ADDENDUM NO. ONE

PROJECT TITLE: Pubic Market Renovation and Expansion

PROJECT NO.: 10064

Invitation to Bid No. C04365

1 SHED B INSIGNIA
SCALE: 3/4"=1'-0"

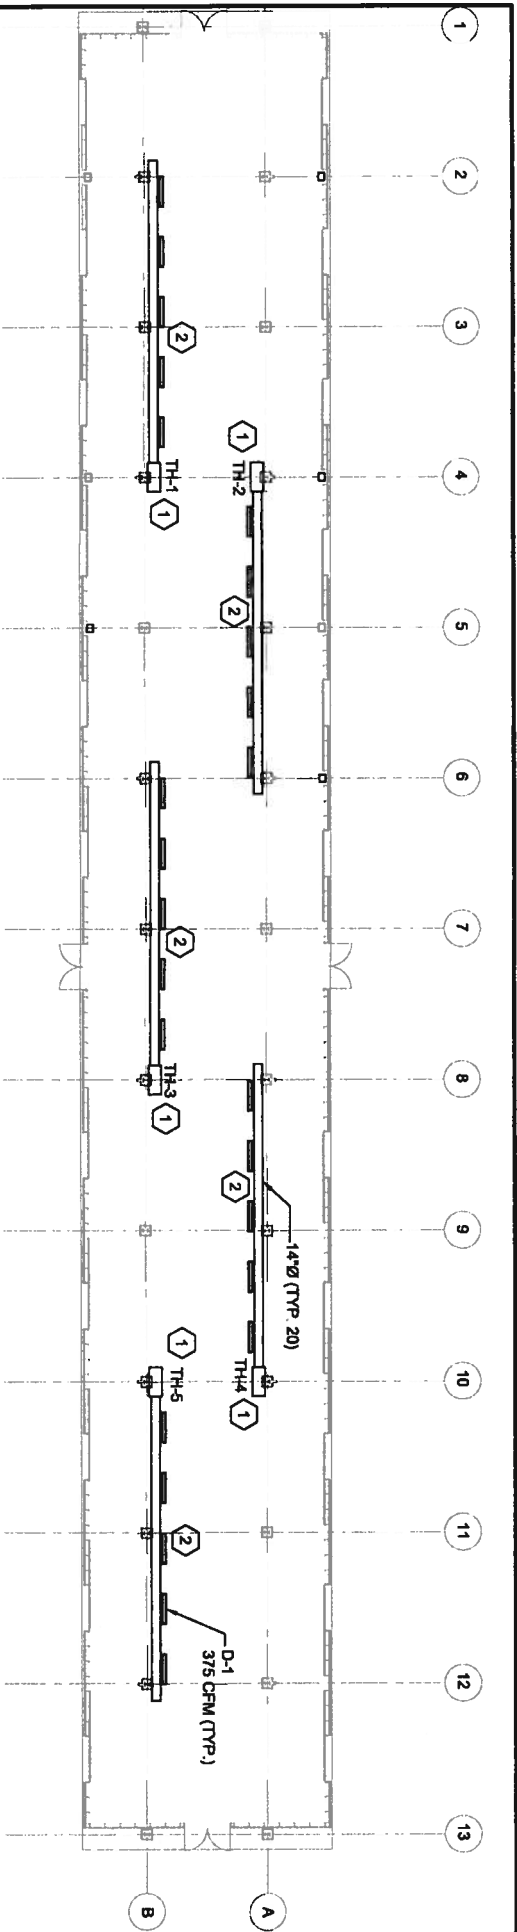
- **Revise** insignia material callout from "3/4" plywood, painted white" to read "aluminum architectural lettering per spec."
4. DMPE 111 In Diffuser, Register and Grille Schedule, **revise** D-1 model to be Titus S301FL. To Shed D Temporary Heating Plan, **revise** location of electric heaters & ductwork per drawing SK-M01.

9. BA 201 To Shed Insignia detail 8, **revise** aluminum signage to aluminum channel lettering, per drawing SK-A01.
10. BE 504 In lieu of detail 5, **replace** with Conduit Trench detail on sheet DC202.

SK-M01

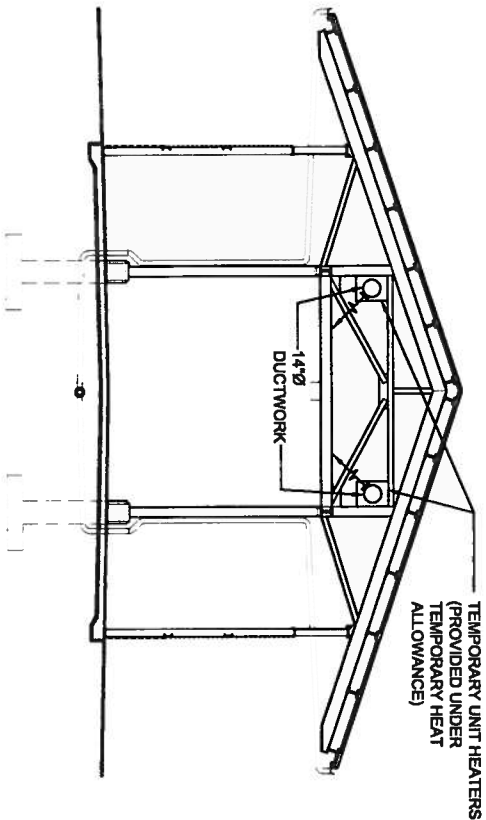
5. DME 501 To Temporary Heating Detail – Shed D, **revise** location of electric heaters & ductwork per drawing SK-M01. **Revise** note calling out temporary heaters to read: "Provided under temporary heat allowance."
